Rio Algom Mining Corp.

Re: Lisbon Facility
License SUA-1119, Docket No. 40-8084
Settlement Monitoring Program

RIO ALGOM MINING CORP.
LISBON FACILITY
AMENDED SETTLEMENT MONITORING PROGRAM

FIGURE 1

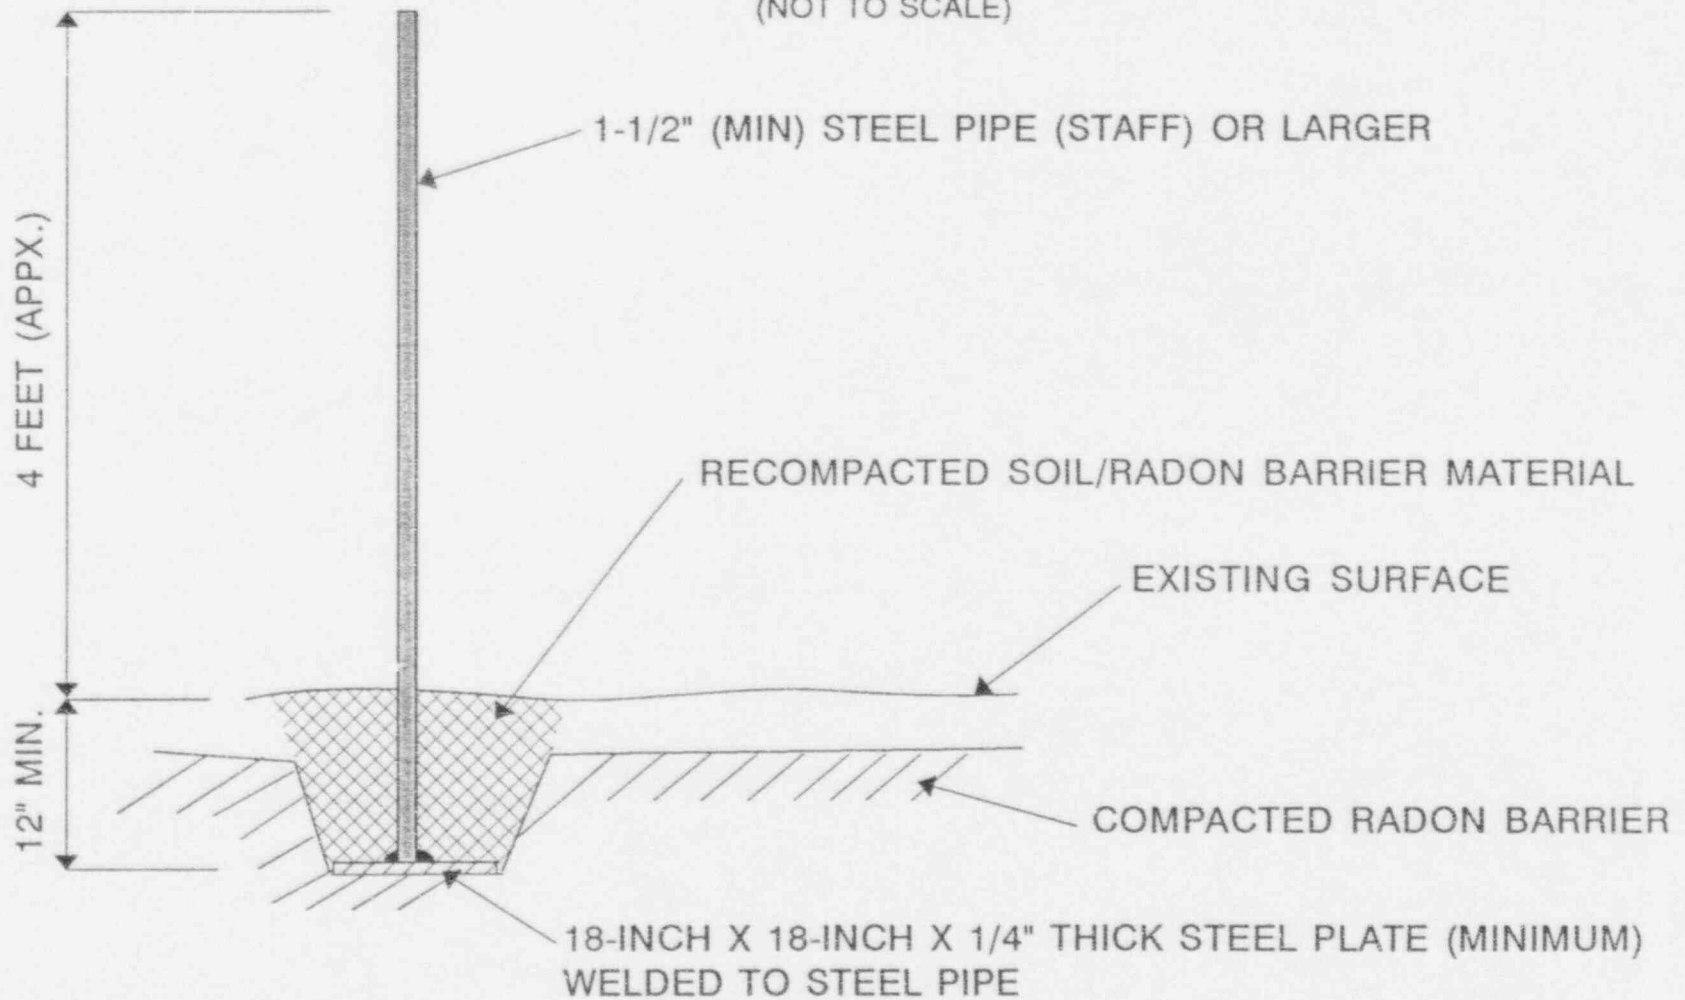
Rio Algom proposes to first modify the settlement monuments. Presently the monuments are to be constructed of aluminum. Due to concerns by NRC staff regarding aluminum, Rio Algom proposes to replace the aluminum with steel. The settlement monuments will be constructed with a steel 18 inch square base with a minimum plate thickness of at least 1/4 inch. The riser or staff of the monument will be steel pipe with a minimum diameter of at least 1 1/2 inch. The height of the staff will be approximately 4 feet and welded to the base plate as shown in Figure 1.

As indicated in Figure 1, the diagram depicts the settlement monument placement on relatively flat surfaces. Settlement monuments associated with the upper and lower tailings evaporation cells will also be constructed in the same manner, but will be placed on the inside slopes of the cell embankments as shown in Figure 2.

The markers will be installed by excavating an area slightly larger than the base plate to a depth of no less than 12 inches below the surface. To the extent possible, the bottom of the excavated area shall be compacted and will be smooth and free of loose debris. The settlement monument will be installed within the excavated area such that the base plate sets firmly on the compacted soils. The area above the base plate will then be backfilled and compacted.

If difficulty is encountered in obtaining a flat smooth surface on which to install the base plate, a cement slurry will be prepared and poured in the bottom of the excavation and the settlement marker plate shall be placed in the wet cement slurry so that the dried material will provide a solid base for the marker. The settlement monuments after installation will be allowed

FIGURE 3

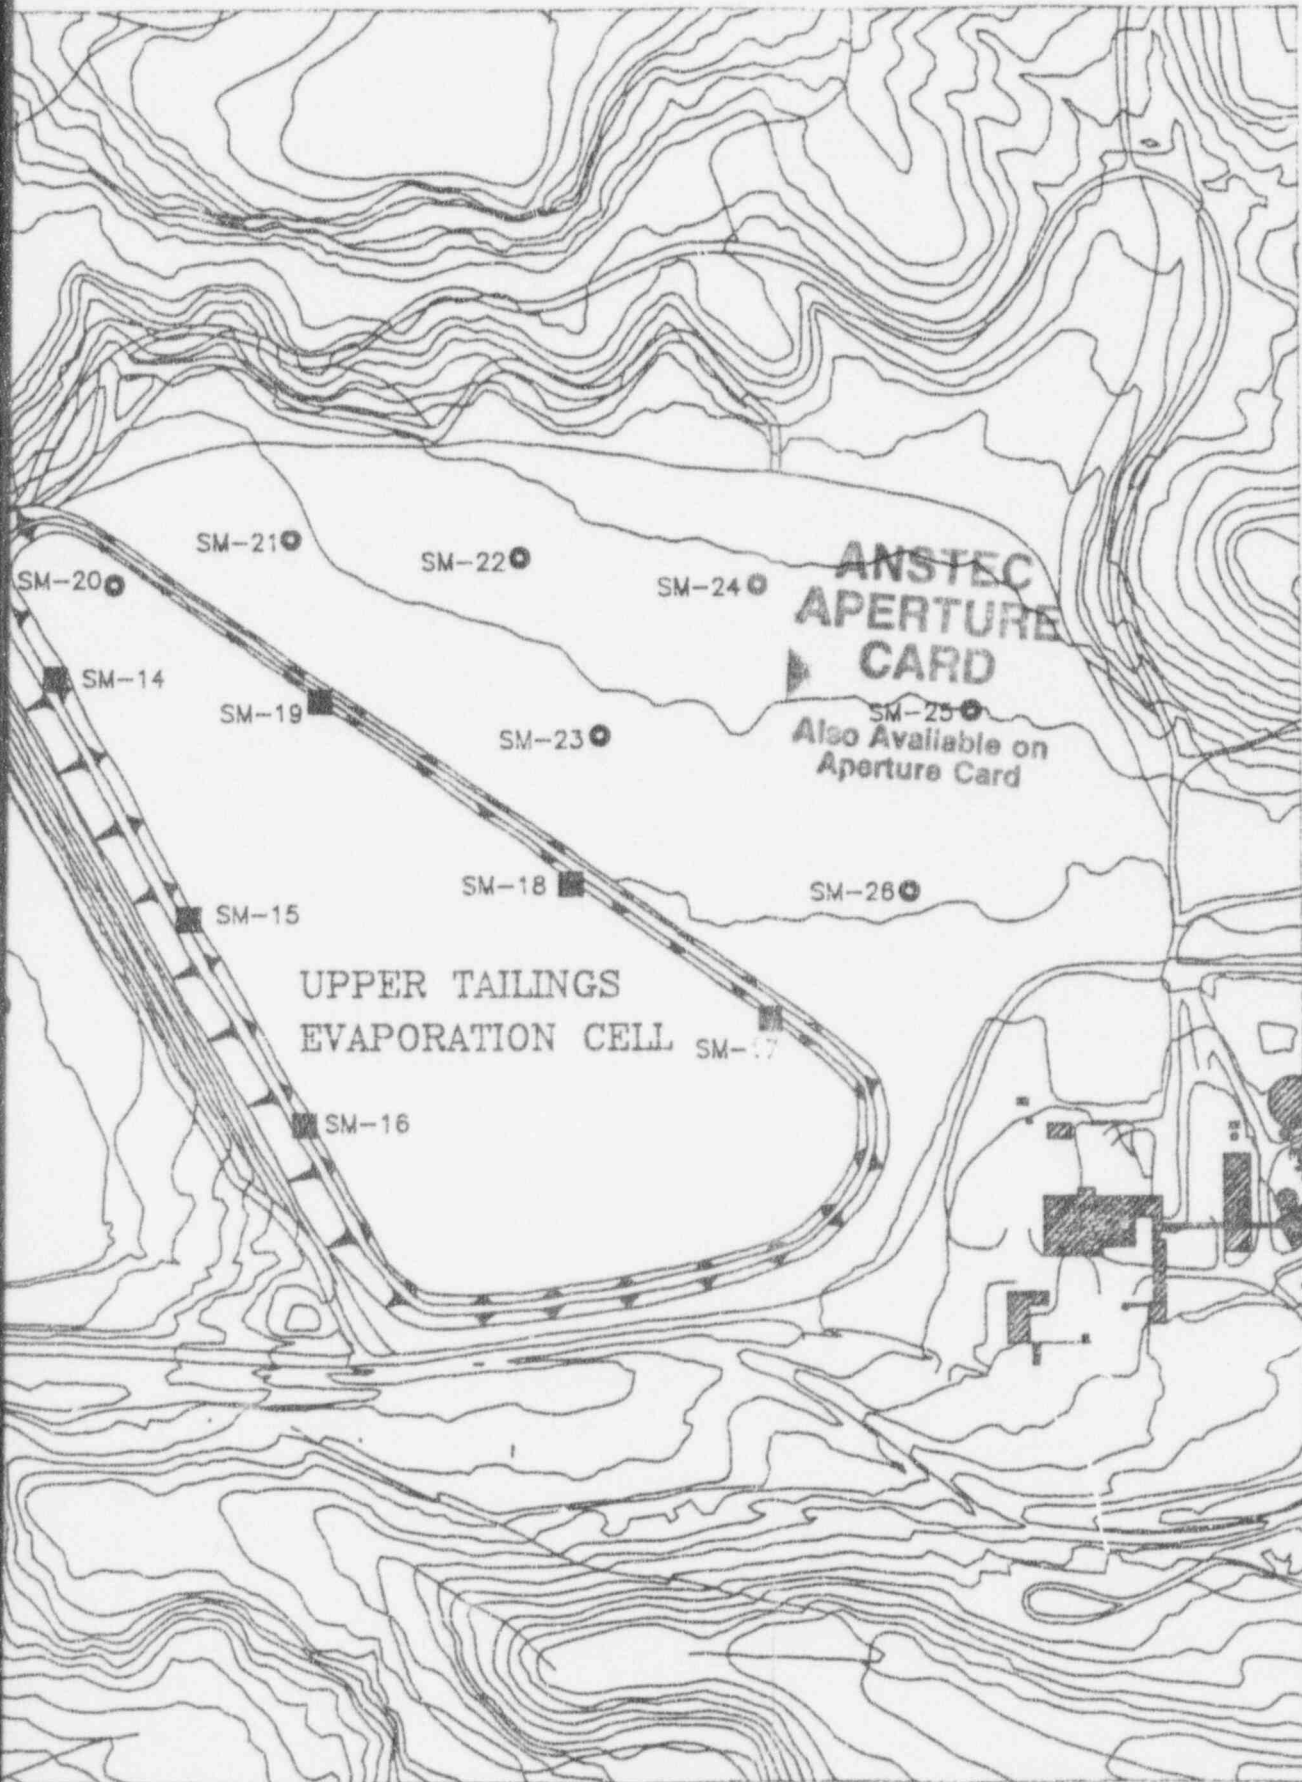
The approximate location of the settlement monuments are shown in Figure 3. Rio Algom proposes to increase the number of monuments associated with the lower tailings area from five (5) to thirteen (13). Eight (8) of the monuments will be utilized to monitor the lower tailings evaporation cell with six (6) of these monuments to be located on the inside of the evaporation cell berms as shown in Figure 2. On the upper tailings area, Rio Algom proposes to increase the number of monuments from five (5) to thirteen (13). Seven (7) of the monuments will be utilized to monitor the upper tailings evaporation cell. Six (6) of these monuments for the upper tailings evaporation cell will be installed on the inside slopes of the cell embankment.
